RFT# 4240 - Addendum #2 Boiler Replacement, Bicentennial School

To: All Bidders
Date: May 29, 2024
From: Nancy Rideout, Purchasing Manager
Office: (902) 464-2000 ext. 2222
Email: nrideout@hrce.ca

3 CHIMNEY AND BREECHING ELEVATION
MH501 NTS

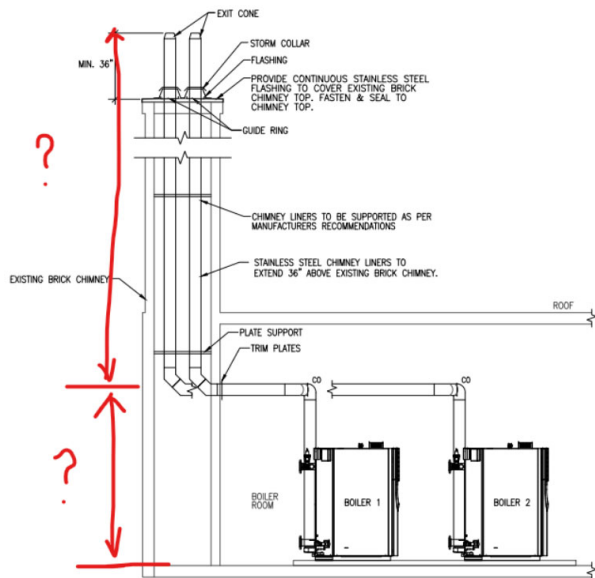
Regarding chimney height:

“The elevation drawing is not to scale. Please provide a scaled elevation drawing or please advise on the dimensions I have marked up on the attached screenshot.”

Find included field measured dimensions on MSK001.
